UNITED STATES PATENT AND TRADEMARK OFFICE

Office Action Summary	Application No. 10/591,887	Applicant(s) FLETCHER, RICHARD EDMOND	
	Examiner Madison L. Wright	Art Unit 3781

DETAILED ACTION

This figure, now referred to as Schram annotated Fig. 1, used for the rejection of claims 4 and 13 has been replicated below, and the Examiner has added reference points for ease of explanation, and said reference points will be used for the rejection of claims 4 and 13 below.

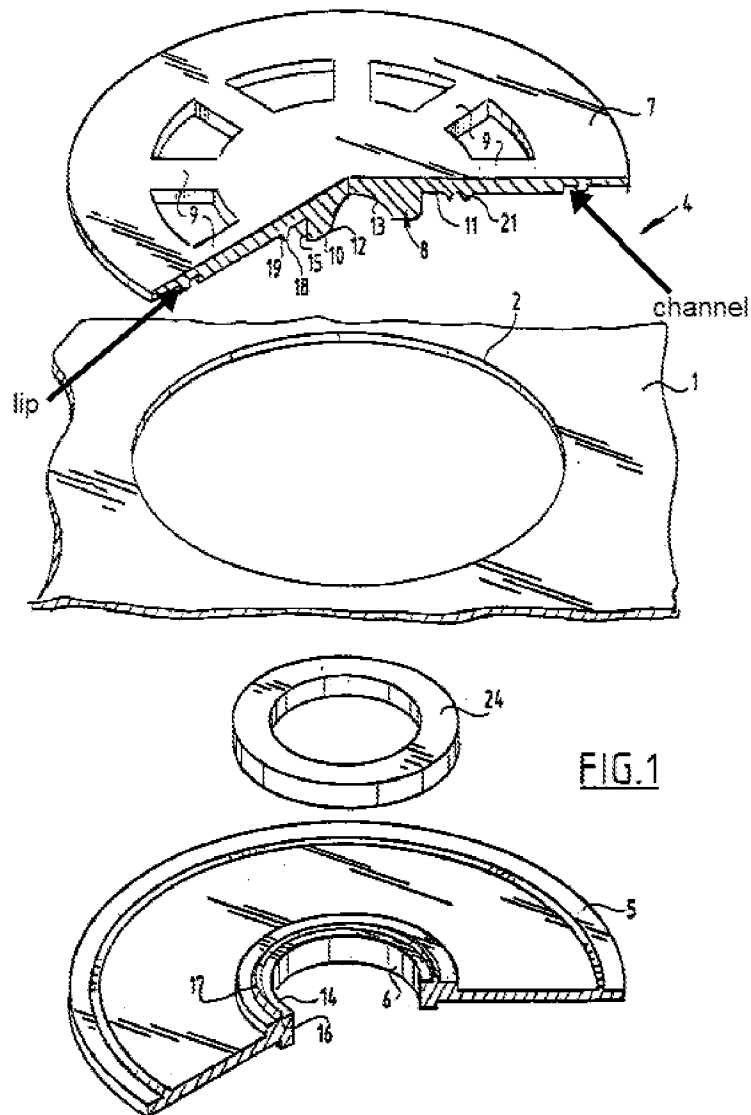
As to claim 4, Schram teaches a fitting as claimed in claim 2 or claim 3 wherein the flange is provided with an annular channel (channel, Schram annotated Fig. 1).

As to claim 13, Schram teaches a fitting as claimed in claim 2 wherein at the location of the joint of the resiliently deformable part (laterally extending wings 9) with the flange (Fig. 3a) there is provided an annular lip (lip, Schram annotated Fig. 1) for locating the fitting within an aperture of the membrane and which upon melting welds the edges of the aperture to the fitting (col. 2, lines 10-14).
